Subject: Liaison Statement to 802.16 on clarification and corrections to the IEEE 802.16 draft standard needed to support WiMAX certification.

WiMAX TWG LS to 802.16 WG, Annex A

Figure 229c—HARQ downlink allocation

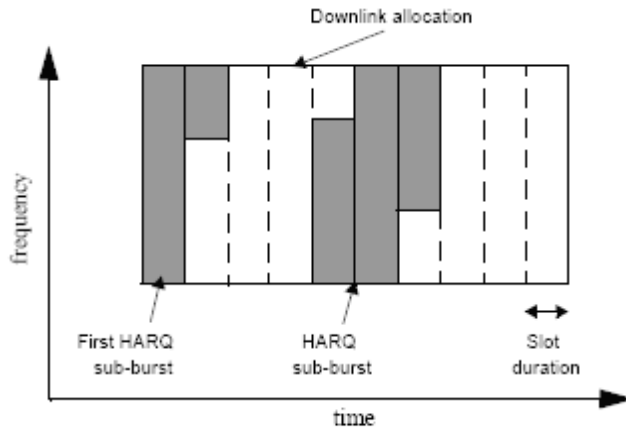
Moreover, for the downlink, HARQ ACK disabled/enabled burst is assigned with 1D allocation as shown in Figure 229c of the standard, which may not have a rectangular shape but may have a snake-shape, while the normal(non-HARQ) burst allocated with normal DL_MAP_IE is always allocated with rectangular shape(2D).
